35 COTTON STREET

APPLICATION FOR PERMIT

Memorandum from Department of Building Inspection, Portland, Maine
35 Cotton Street—Installation of gasoline storage tank for Earle H. Boyes &
Son by Valley Pump & Tank Company, installers

Subject: Application for building permit to cover
demolition of one-half of the double tenement
house at 37-39 Cotton Street, the half proposed
to be demolished being at 37 and the half at
number 39 being owned by others.

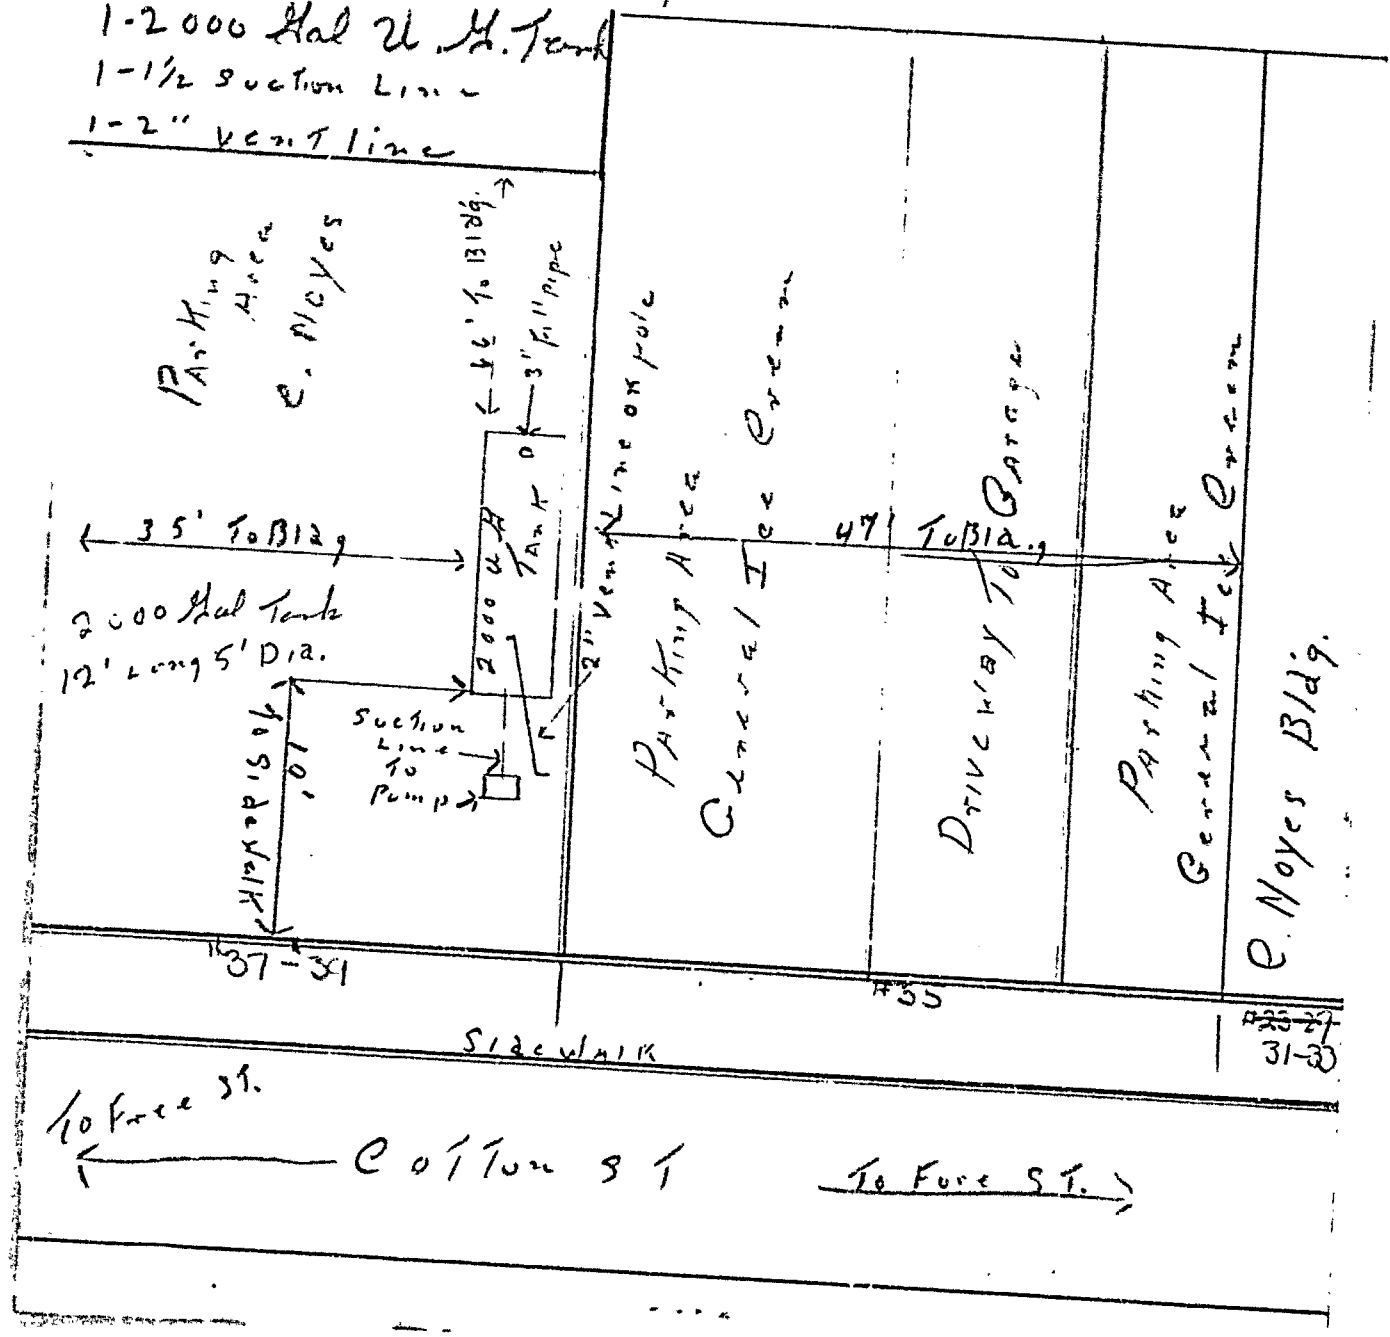
- 1-Model 1-96-H + B Pump
- 1-2000 Gal U. H. Tank
- 1-1 1/2 Suction Line
- 1-2" Vent Line

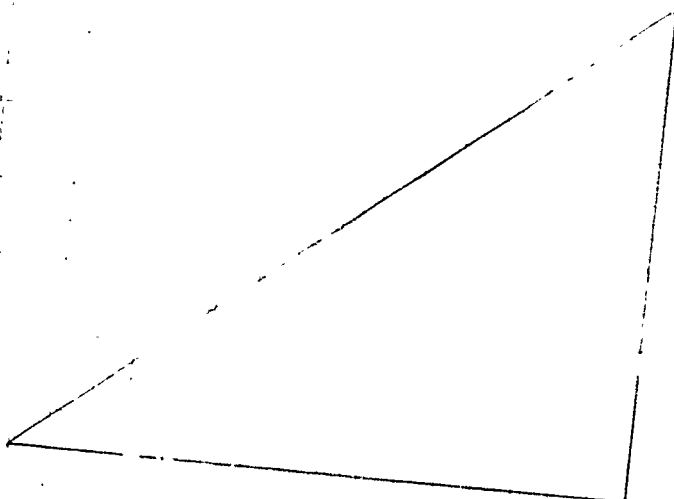
Under the circumstances I feel that I cannot issue this permit until considerable more information is forthcoming and definite assurance is given in writing as to the protection of the family which I understand is still occupying the highest floor of this part to be demolished and by plan a description of how the remaining portion of the building at 39 owned by others is to be rendered substantial. I would prefer and perhaps shall have to insist upon some sort of statement in writing from the owner of the part at 39 making clear that owner's understanding of the proposition and her consent to do whatever work is necessary on parts of her ownership not only in removing the part to be demolished but to render permanently safe and protected from the weather the part which she owns.

It seems likely that the party wall or partition between the two sides of the building as far as that part below the highest floor is concerned is probably a bearing partition, is now carrying more load than it would after the demolition, and is probably bisected longitudinally by the line of property ownership. On the front part or main part of the building there is a gable roof however, the ridge being probably over the line of ownership and the rafters pitching downwards from this ridge over the land of the respective owners on either side. In many such gable-end pitch roofs the ridge is not supported straight down through the building but depends upon the rafters on either side to hold it and each of or up at the peak, the rafters in turn to be supported upon the exterior walls on either side which are kept from spreading either by the upper floor joists or collar beams. Certainly it is necessary to demonstrate that the half of the roof at 39 either is even now well supported on the central partition at the ridge or will be made so. The entire picture of the building is not clear in my mind, but other complications may arise where I believe the rear end of both sides of the building has a gable end roof with ridge running parallel to Cotton Street.

has nothing to do with appearance; but this peculiar prospect makes it all the more necessary that I shall be certain that the final structure will be entirely safe and reasonably close to Building Code standards therefor. It may be that negotiations with the owner at 29 may result in removal of the pitch roof at that side of the building also and introducing either a new normal pitch roof covering that part only or else a flat roof covering that part.
